## City of Mississauga Department Comments

File(s): A452.21 Ward 11

The applicant requests the Committee to approve a minor variance to allow the construction of a driveway with a width of 6.7m (approx. 21.98ft) whereas By-law 0225-2007, as amended, requires a maximum driveway width of 5.2m (approx. 17.06ft) in this instance.

Property Address: 7432 Magistrate Terr

### Appendix 1 – Transportation and Works Comments

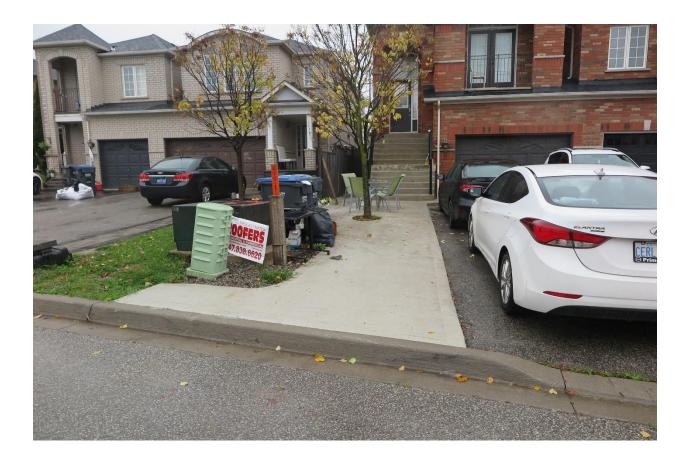
This department notes that with regard to the widened driveway within the municipal boulevard (the area between the municipal curb and property line) we would request that this area be reinstated with topsoil and sod should the application be modified to reflect a smaller driveway width within the subject property or if the application is not supported by the Committee.

From our site inspection and enclosed photos we note that there is an existing hydro transformer box, a cable box and a telephone utility within the boulevard area. The applicant has widened the driveway in such a manner that the concrete abuts (or in very close proximity) to the utilities mentioned. The driveway, including any concrete area must be a minimum of 1.5M away from any utilities and in this regard this area must be re-instated with topsoil and sod. There is also a tree planted within the widened concrete, we are not sure if this is a city tree but noting that this tree will also be impacted by the concrete.
